**SAN ANTONIO WATER SYSTEM**  
**Interdepartment Correspondence Sheet**

**Subject:** Zoning Case Z2016040 (S & A Management Multi-Family)

**Date:** December 18, 2015

ZONING FILE: S & A MANAGEMENT MF (FIGURE 1)  
ZONING CASE: Z2016040  
MAP GRID: 131, F5

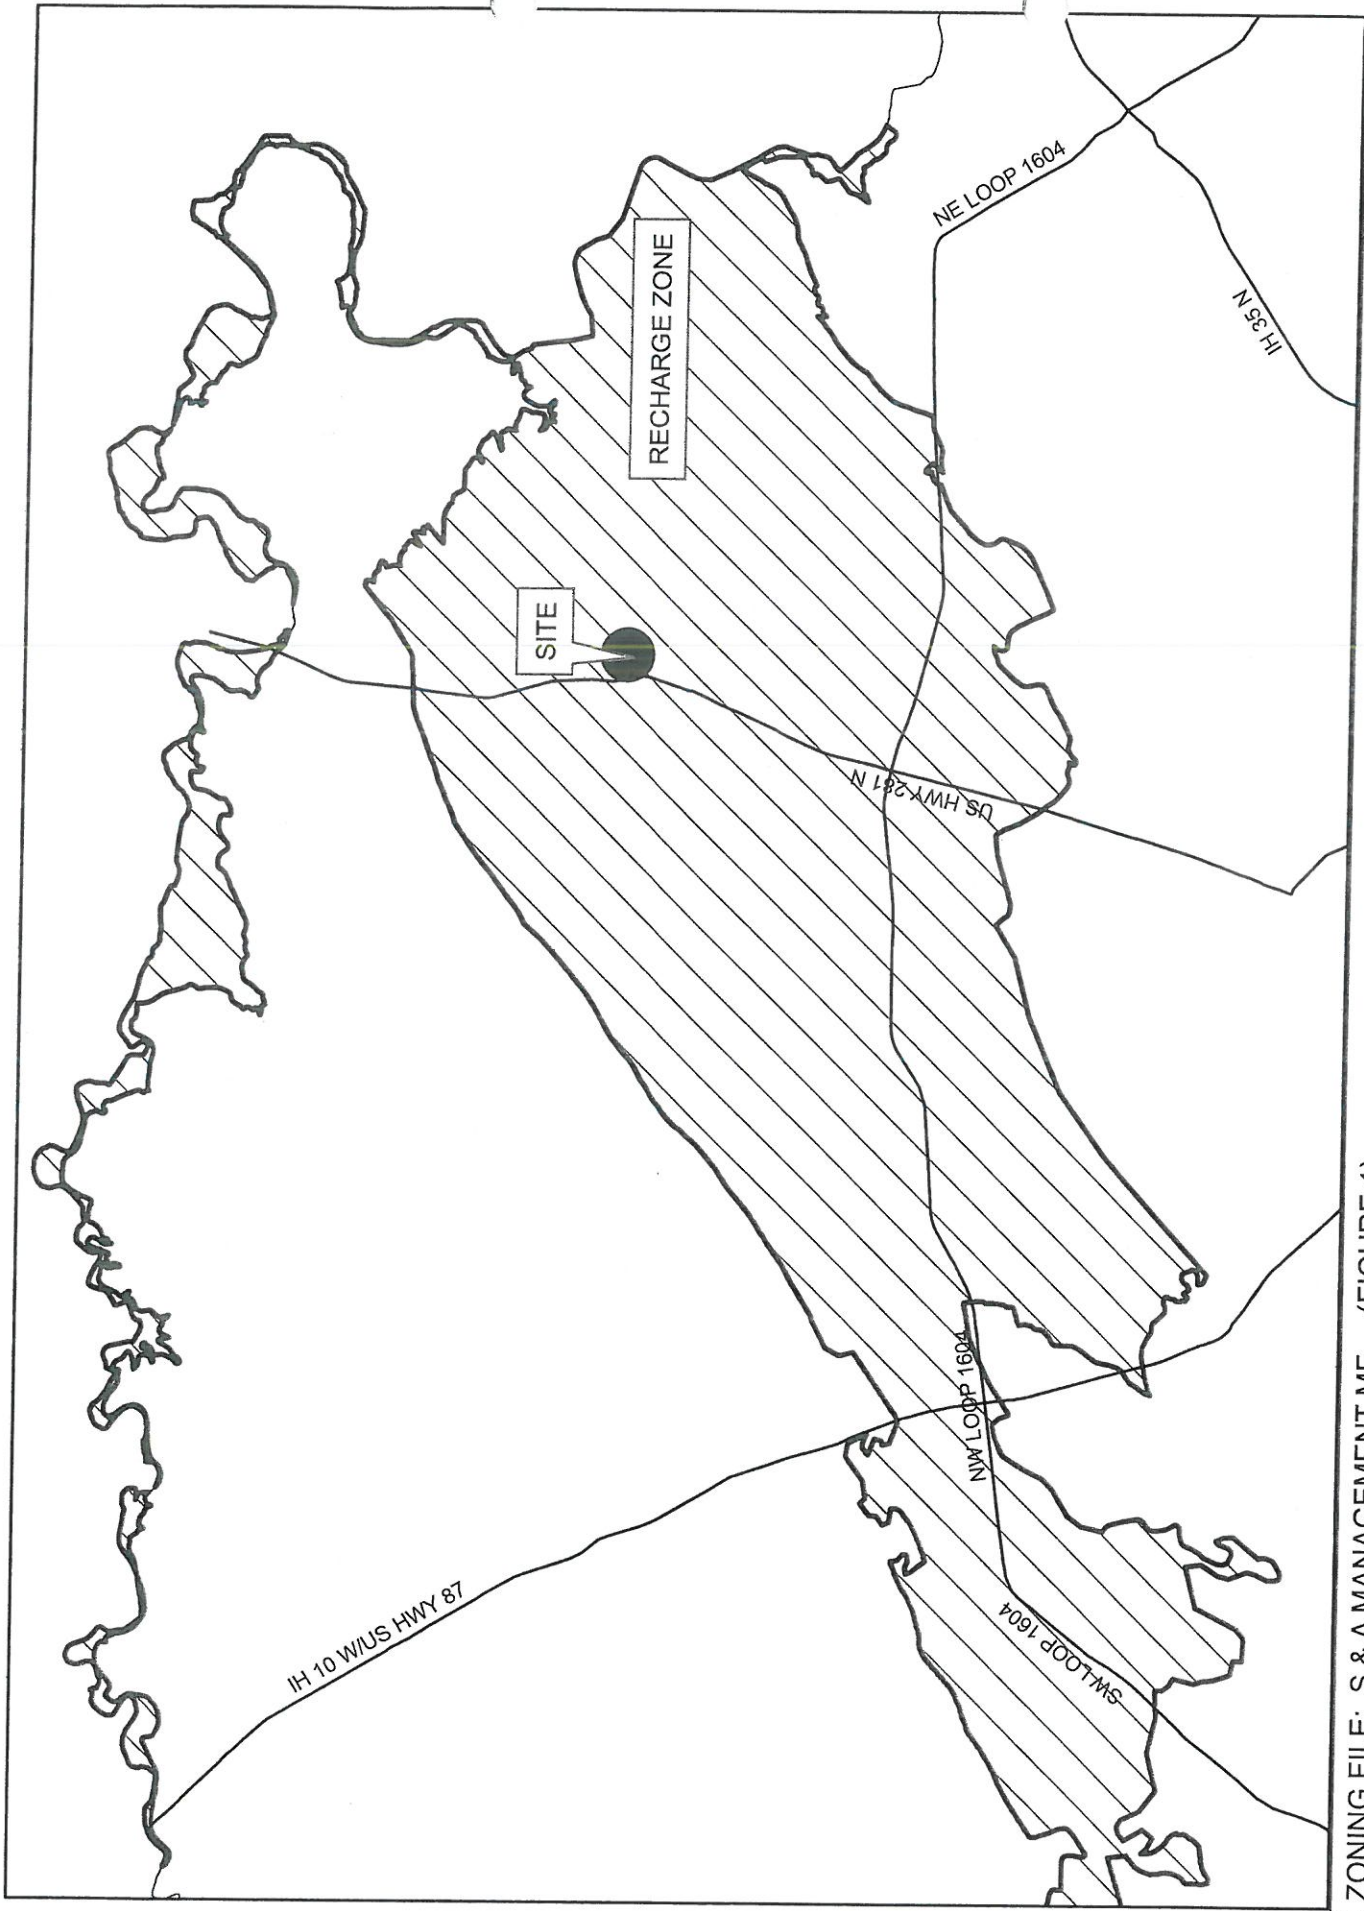
The subject property is located in City Council District 9, approximately 1,305 feet south of Marshall Road on U.S. Highway 281 North. The property lies within the Edwards Aquifer Recharge Zone (Figures 1 and 2).
